ADDITION TO 7106 POPLAR AVE. TAKOMA PARK, MD

Staff Item
Anne Fothergill
August 13, 2008

MEMORANDUM

MONTGOMERY COUNTY HISTORIC PRESERVATION COMMISSION
STAFF REPORT

8/1/08
Proposed new rear elev.

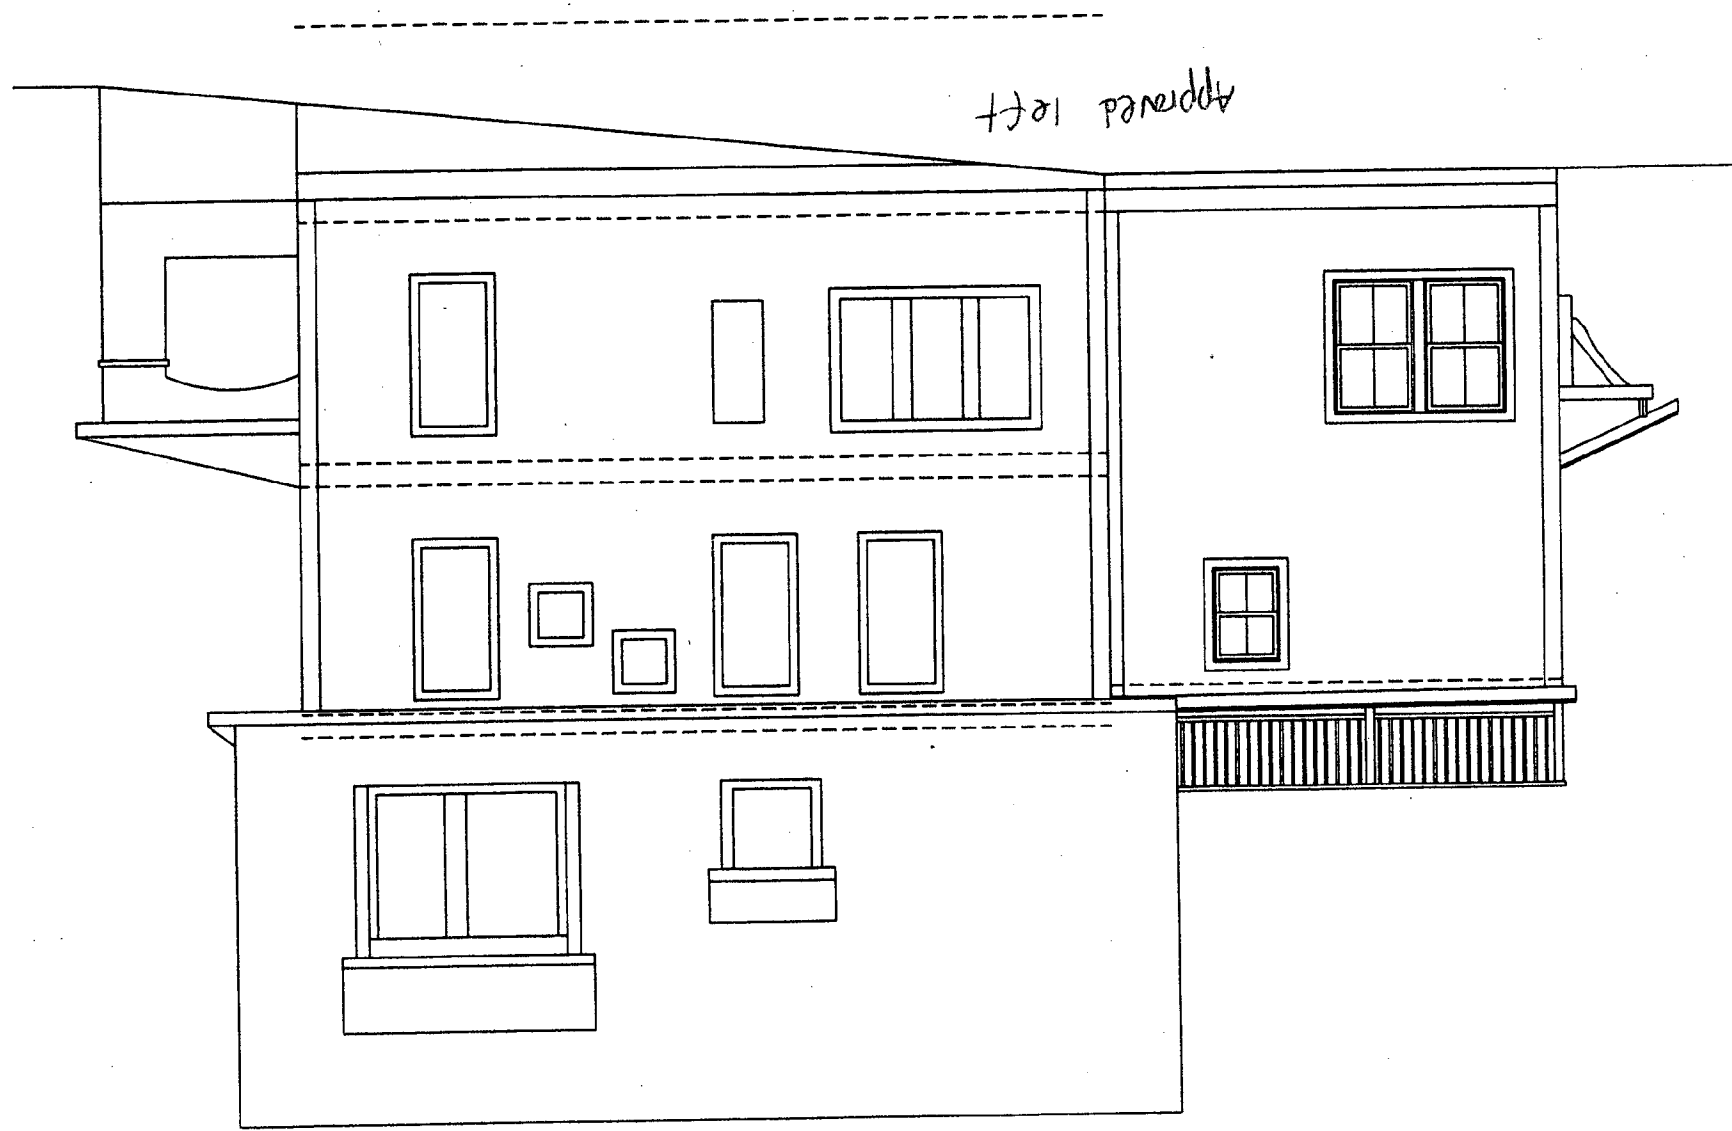
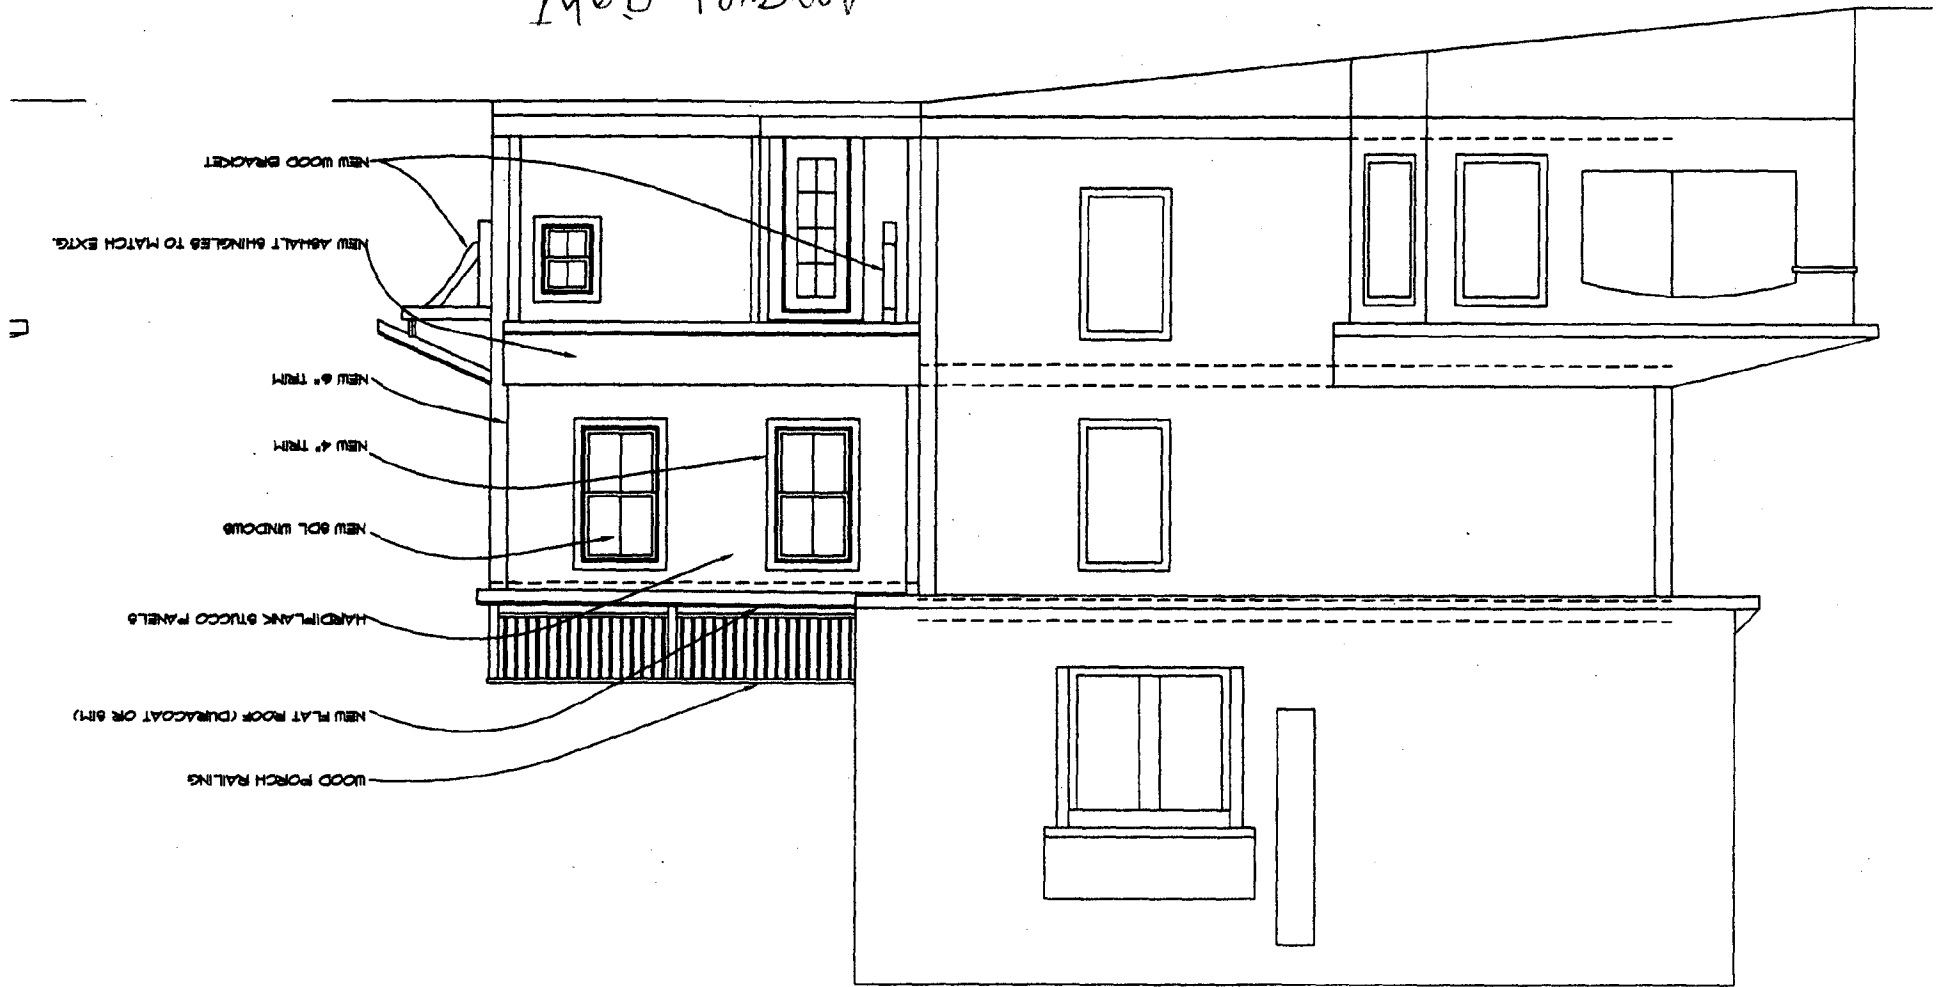
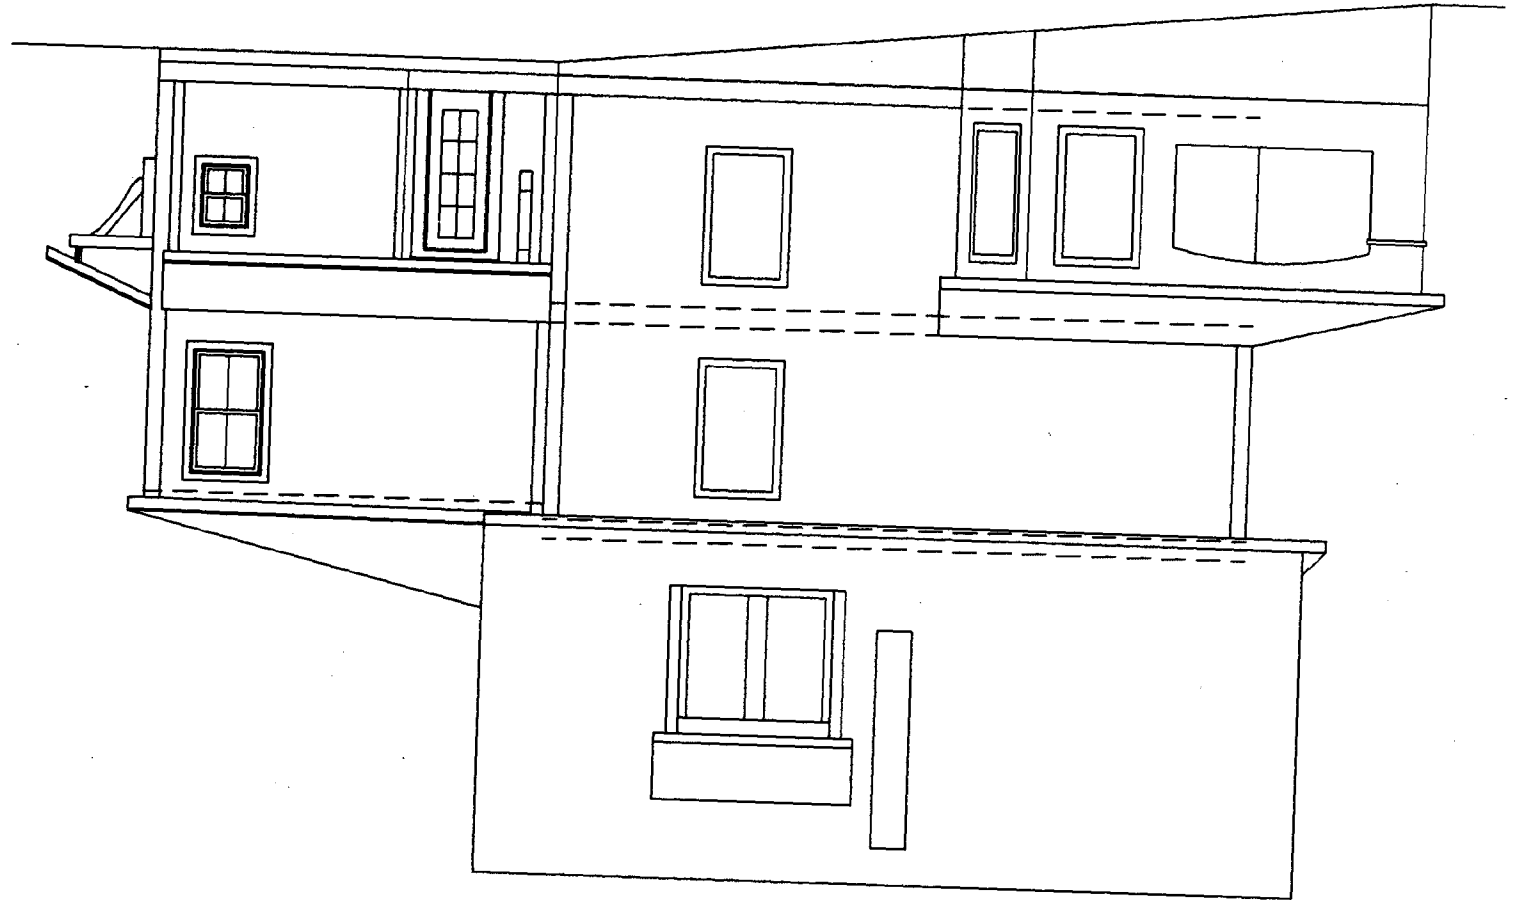
The changes are window locations, they have changed on all three sides. Also, the rear roof at the rear door is larger now and extends over the windows on the right side.

Also, the roof is now going to be sloped and will be done with asphalt shingles to match the main house!

Proposed new 1st Fl.
8/1/08.

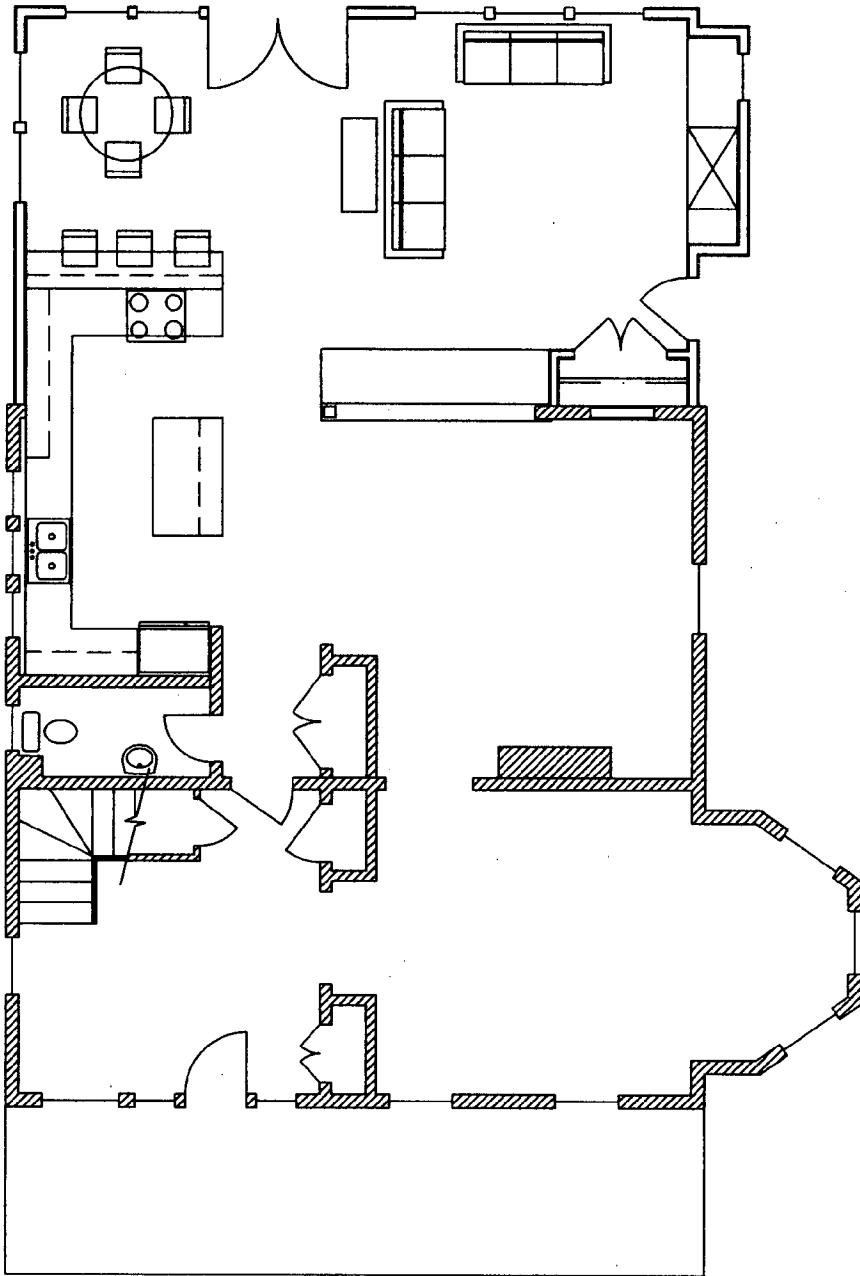
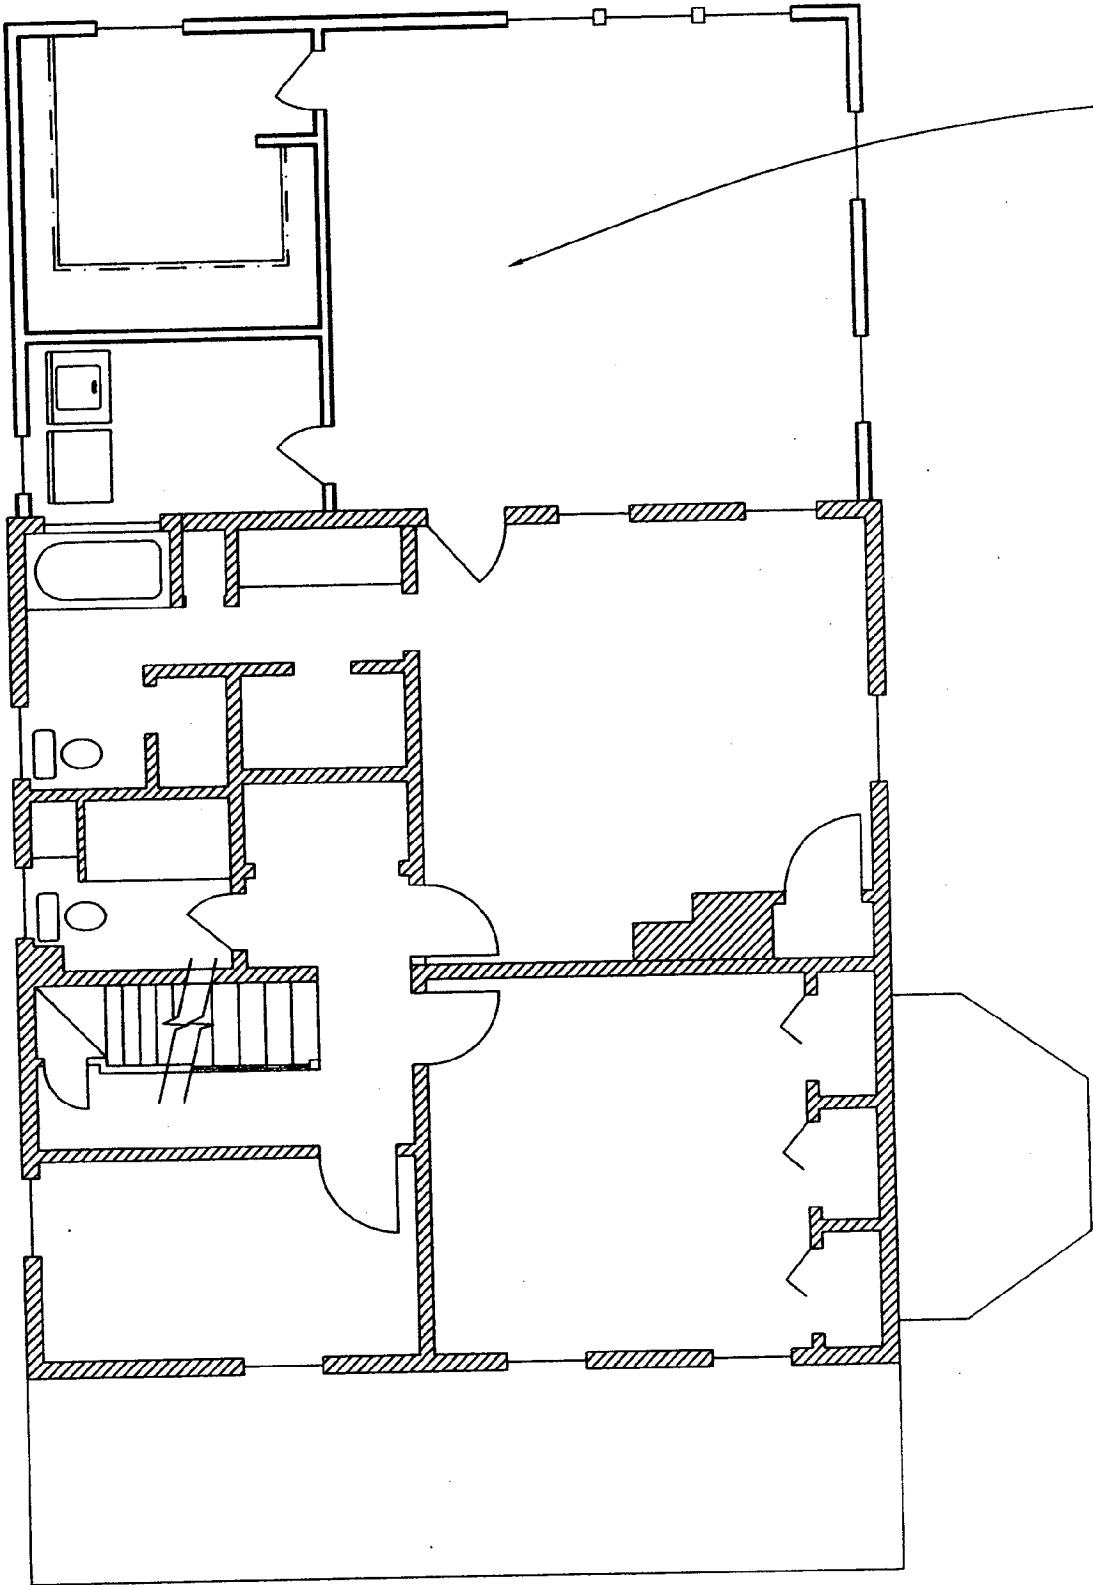
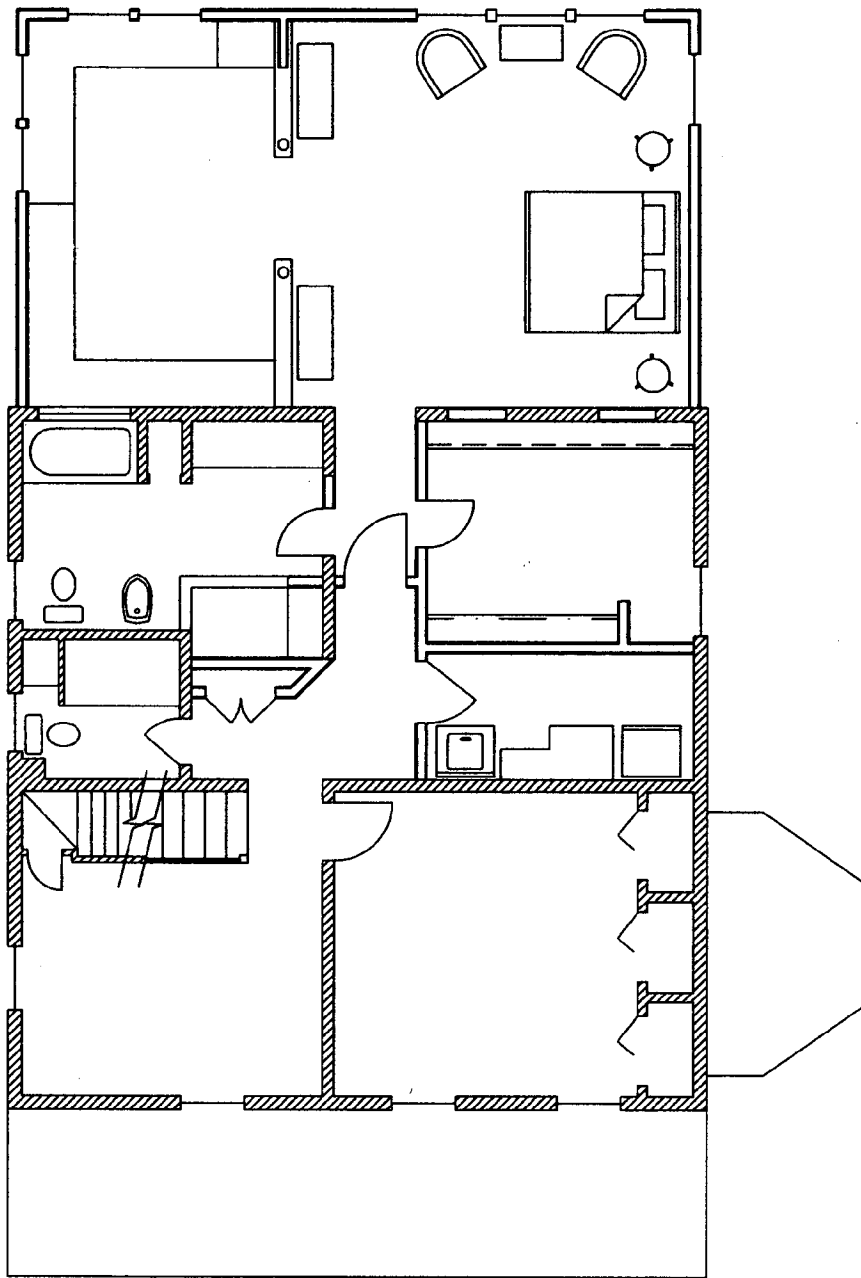
Enclosed you will find the original drawings that you took to the review board for a revision for the project located at 7106 Poplar Ave.. I have also enclosed the new drawings. The footprint of the building remains the same.
